World Forum for Harmonization of Vehicle Regulations

Proposal for the 03 series of amendment to UN Regulation No. 127 (Pedestrian safety)

Submitted by the Working Party on Passive Safety *

Figure 5
Example of marking of HIC1000 zone and HIC1700 zone

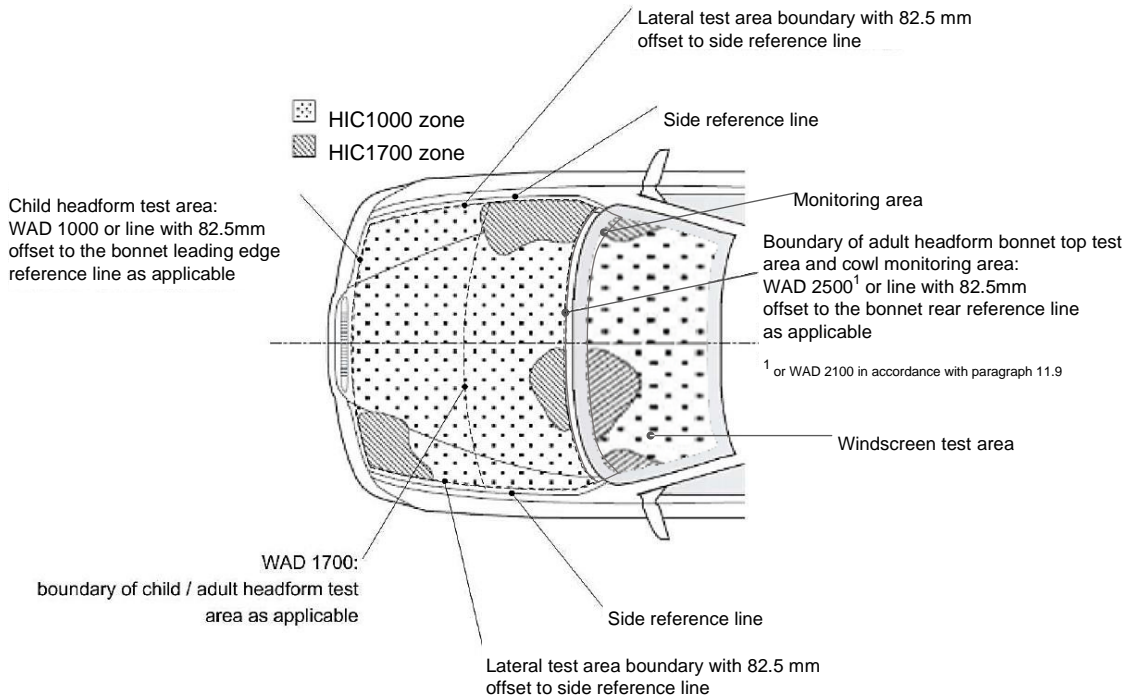
3.4.1. The manufacturer shall identify the zones of the bonnet top test area and of the windscreen test area where the HIC shall not exceed 1,000 (HIC1000 zone) or 1,700 (HIC1700 zone) (see Figure 5).

3.4.2. Marking of the "bonnet top" test area, marking of the windscreen test area as well as "HIC1000 zone" and "HIC1700 zone" will be based on a drawing supplied by the manufacturer, when viewed from a horizontal plane above the vehicle that is parallel to the vehicle horizontal zero plane. A sufficient number of x and y co-ordinates shall be supplied by the manufacturer to mark up the areas on the actual vehicle while considering the vehicle outer contour in the z direction. The cowl monitoring area is not considered for the marking of the "HIC1000 zone" and "HIC1700 zone".

3.4.3. The areas of "HIC1000 zone" and "HIC1700 zone" may consist of several parts, with the number of these parts not being limited. The determination of the impacted zone is done by the measuring point.

3.4.4. The calculation of the surface of the bonnet top test area and the calculation of the surface of the windscreen test area as well as the surface areas of "HIC1000 zone" and "HIC1700 zone" shall be done on the basis of a projected bonnet and windscreen when viewed from a horizontal plane parallel to the horizontal zero plane above the vehicle, on the basis of the drawing data supplied by the manufacturer."
